AMENDMENT E CHANGES. SHOWN CLOUDED.

DEVELOPMENT APPLICATION SUBMISSION FOR:

41 & 43 BEACH ROAD,COLLAROY, 2097
LOT 1 DP300846 & LOT 2 SEC 7 DP7391

PROJECT	DATE	REVISION NUMBER
41 & 43 BEACH ROAD COLLAROY LO1 1 DP300846 AND LOT 2 SEC 7 DP7391	20/08/2020	**E**
DRAWING TITLE	**SCALE:**	**DRAWING NO.**
COVER + PHOTOMONTAGES	N/A	**DA 000**

01 PARTIAL SECTION B-B'

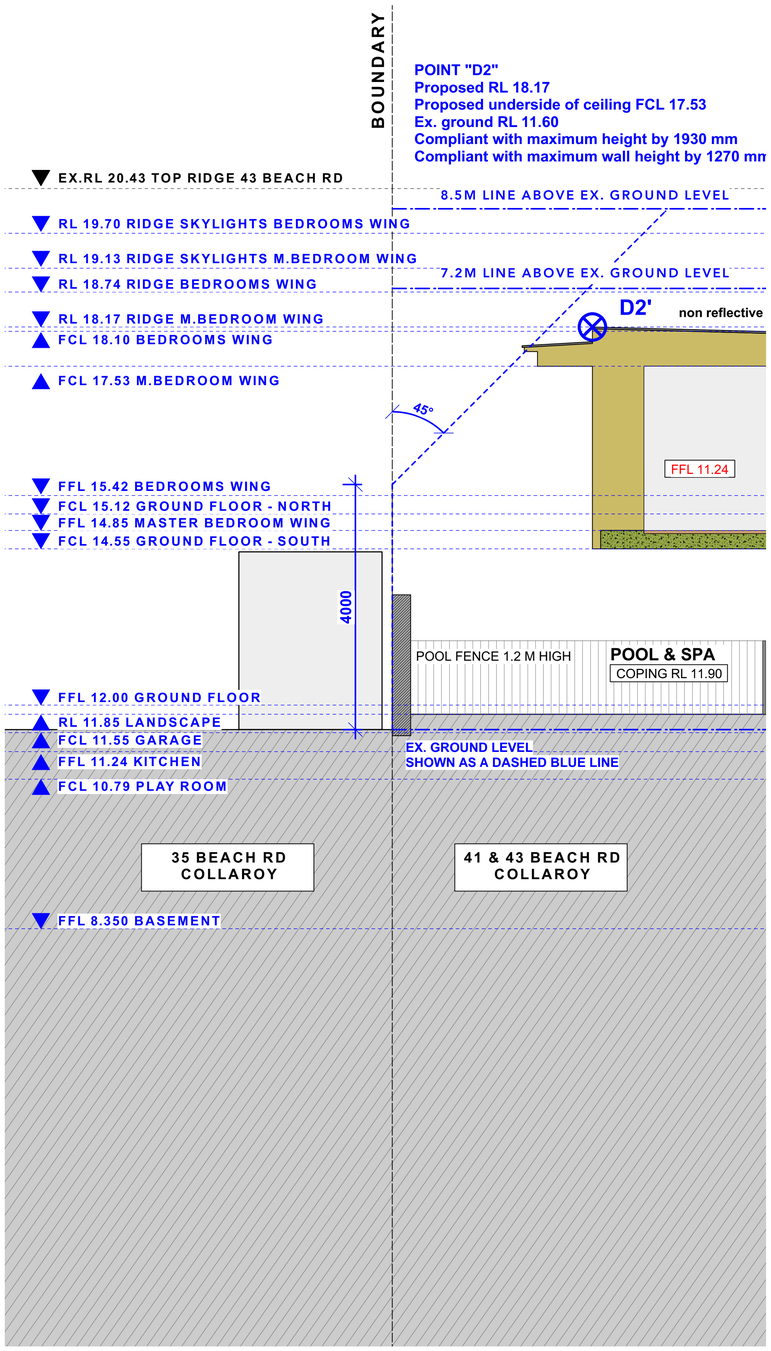
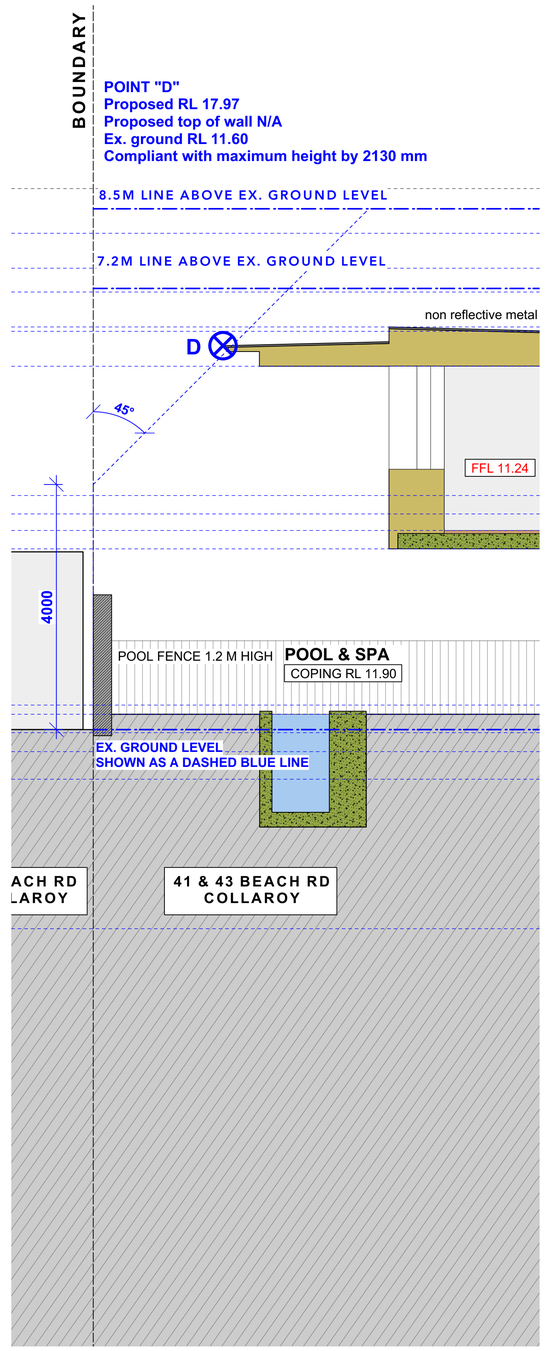
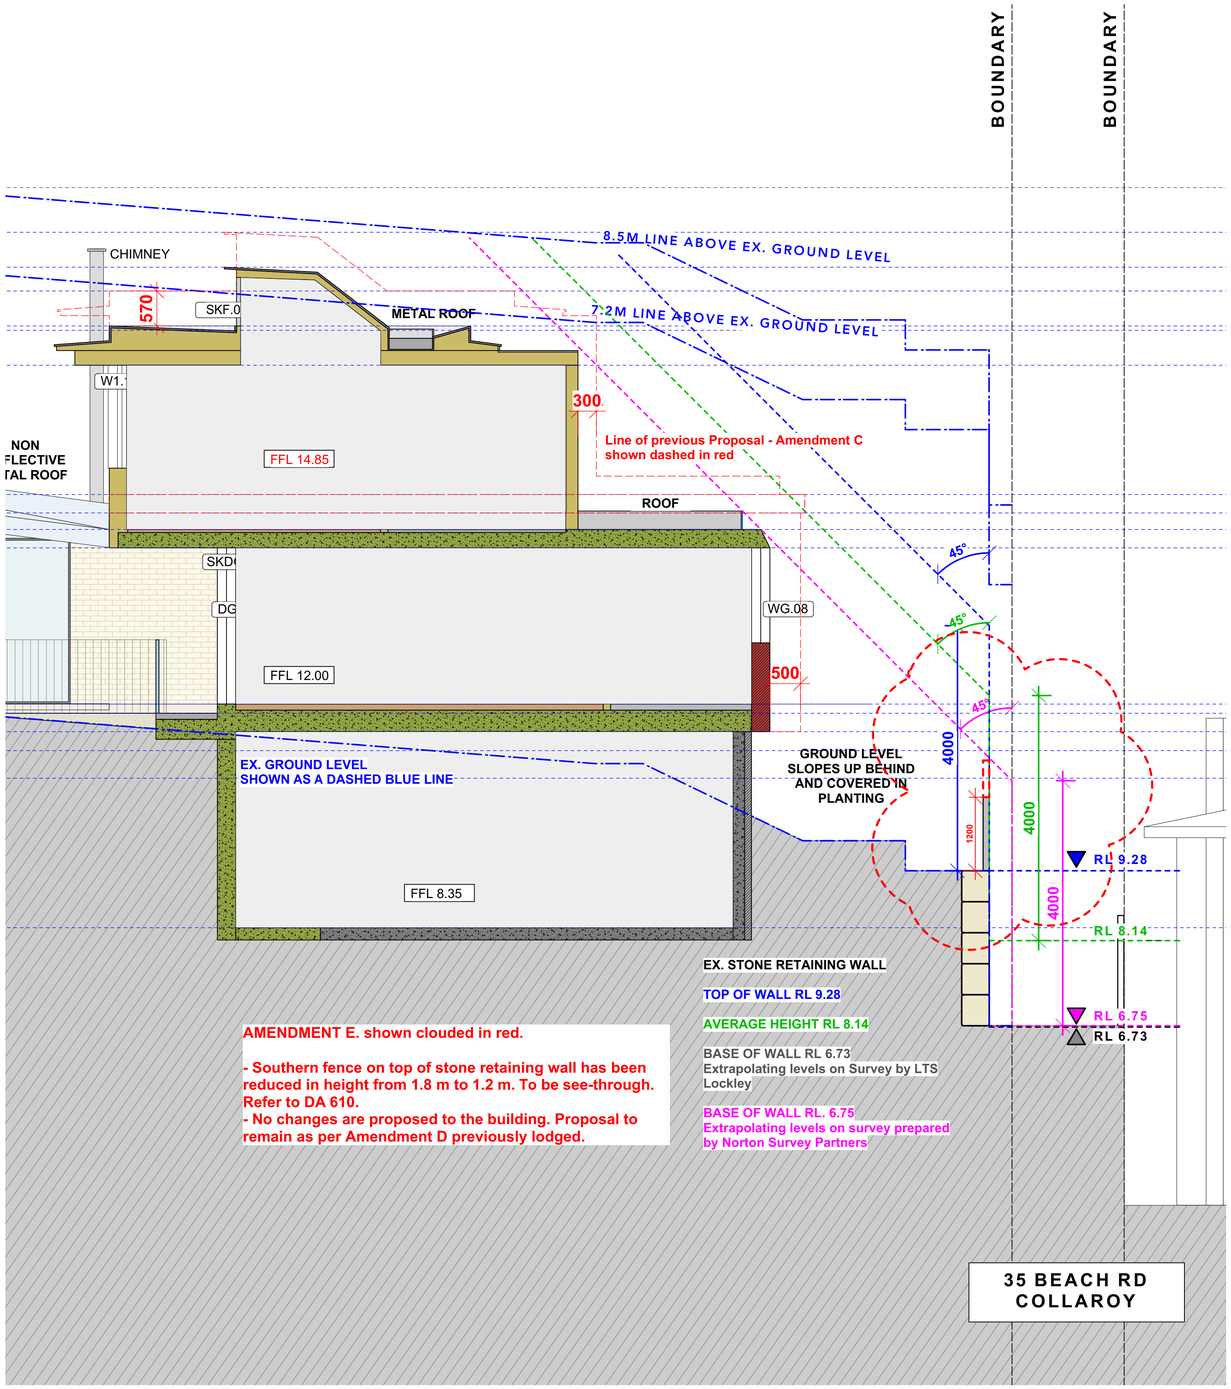
- Southern fence on top of stone retaining wall has been reduced in height from 1.8 m to 1.2 m. To be see-through. Refer to DA 610.
- No changes are proposed to the building. Proposal to remain as per Amendment D previously lodged.

01 **SECTION A-A'**

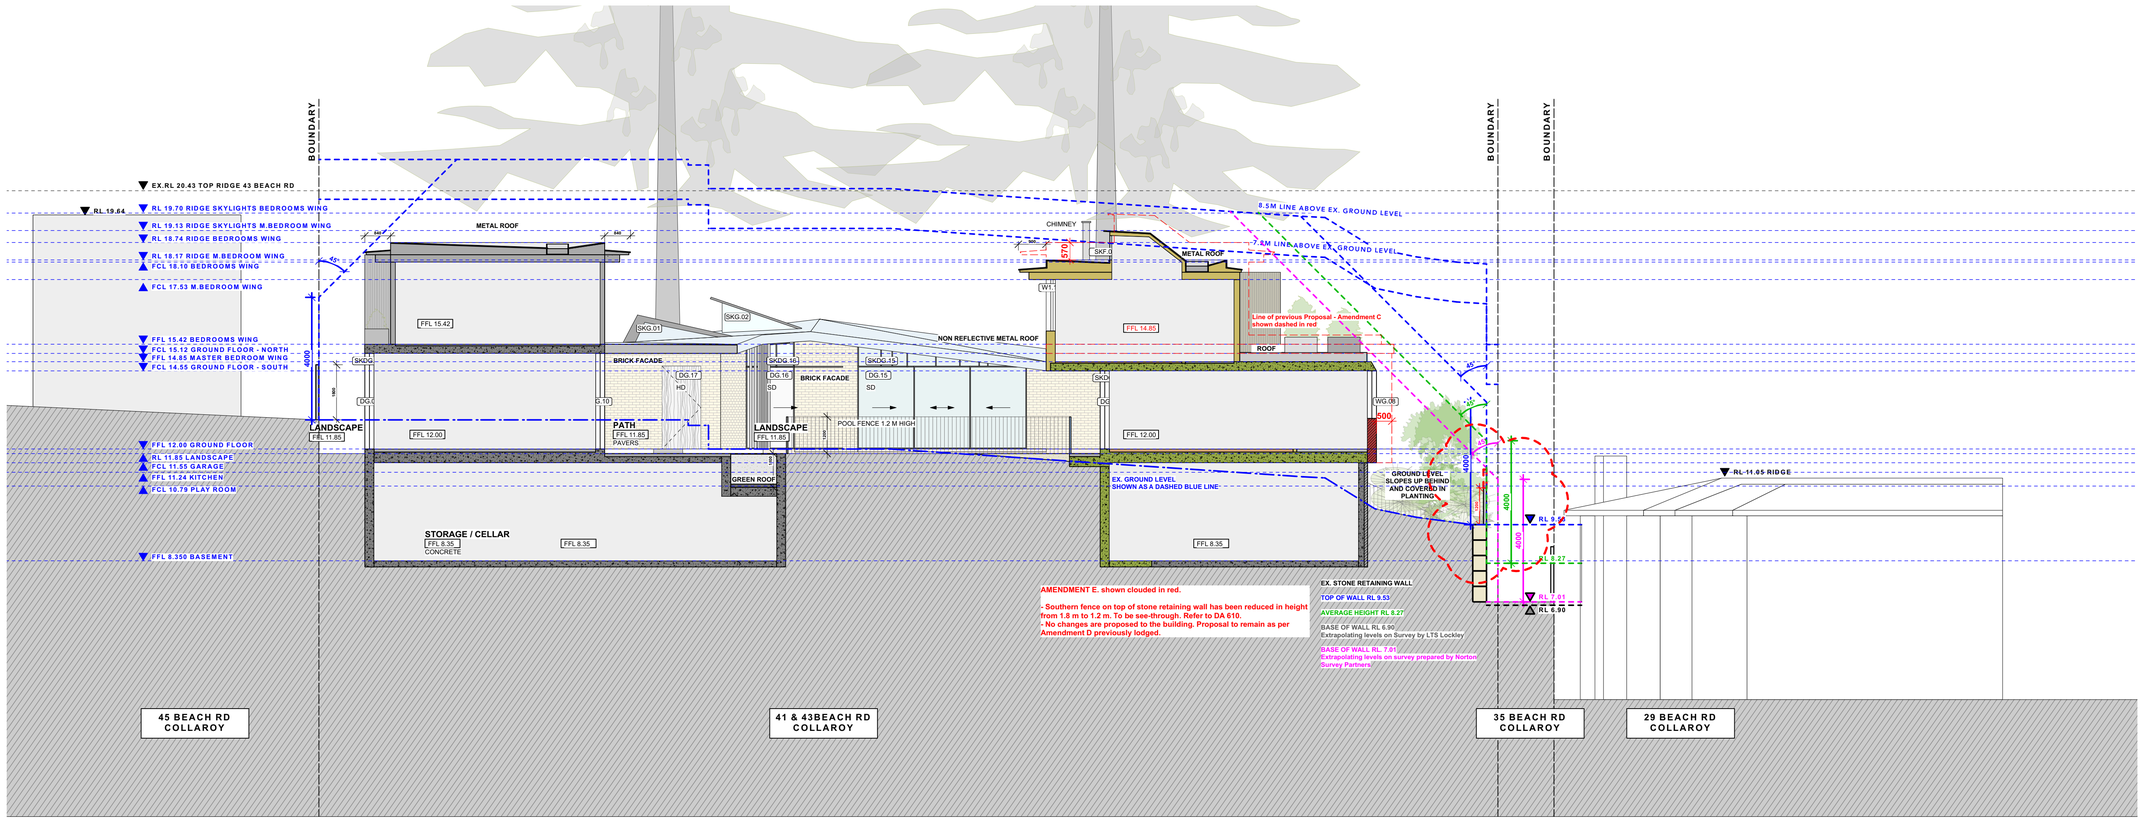
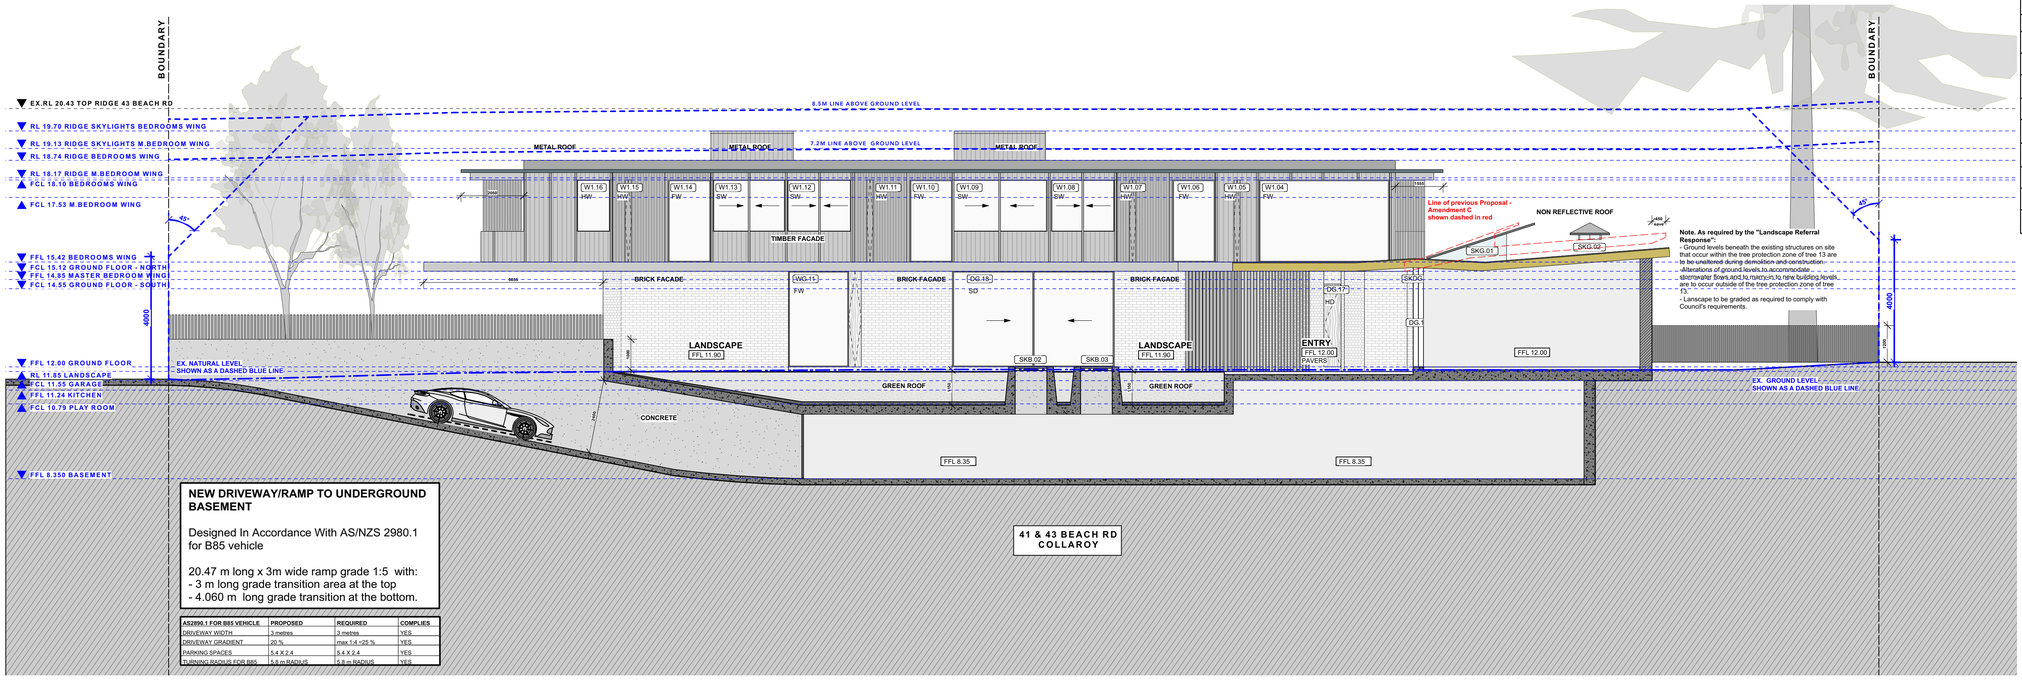
AMENDMENT E. shown clouded in red.
- Southern fence on top of stone retaining wall has been reduced in height from 1.8 m to 1.2 m. To be see-through. Refer to DA 510.
- No changes are proposed to the building. Proposal to remain as per Amendment D previously lodged.

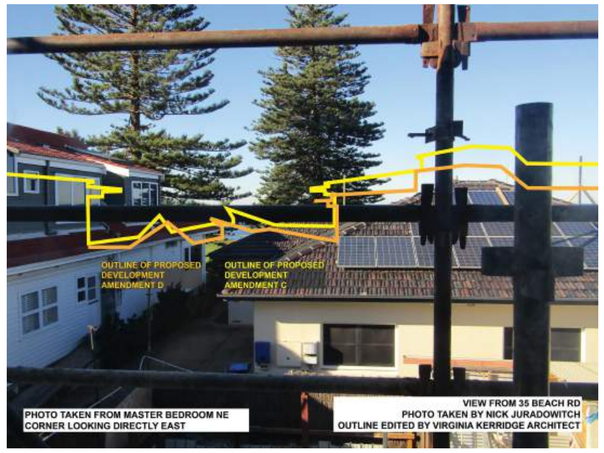
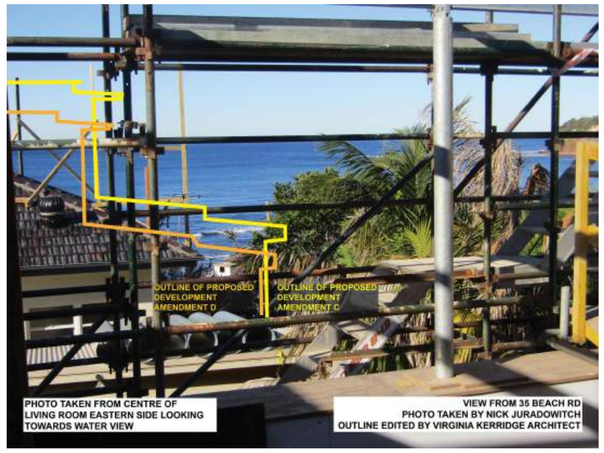
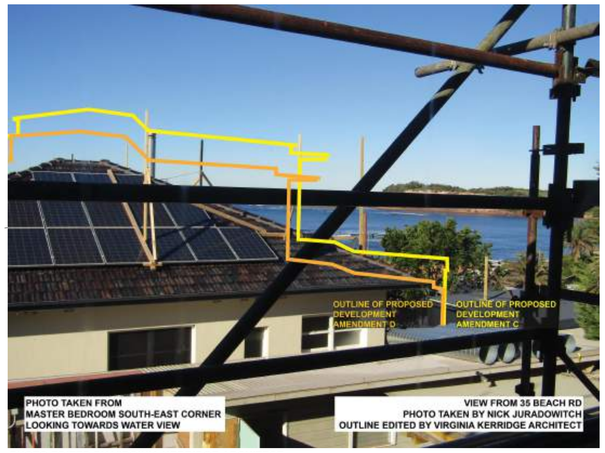
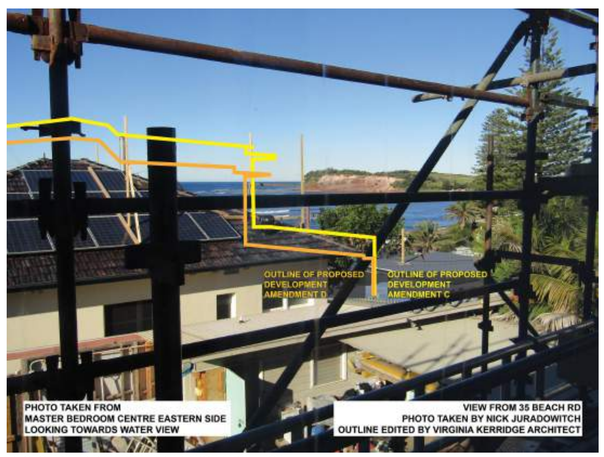
VIEWS FROM FISHERMANS BEACH AND THE RESERVED HAVE BEEN UPDATED WITH NEW PROPOSAL.
DRAWING REGISTER UPDATED.

PHOTO EDITED BY VIRGINIA KERRIDGE ARCHITECT.
OUTLINE OF PREVIOUS PROPOSED DEVELOPMENT SHOWN AS A YELLOW LINE - AMENDMENT C
OUTLINE OF CURRENT PROPOSED DEVELOPMENT SHOWN AS AN ORANGE LINE - AMENDMENTS D & E
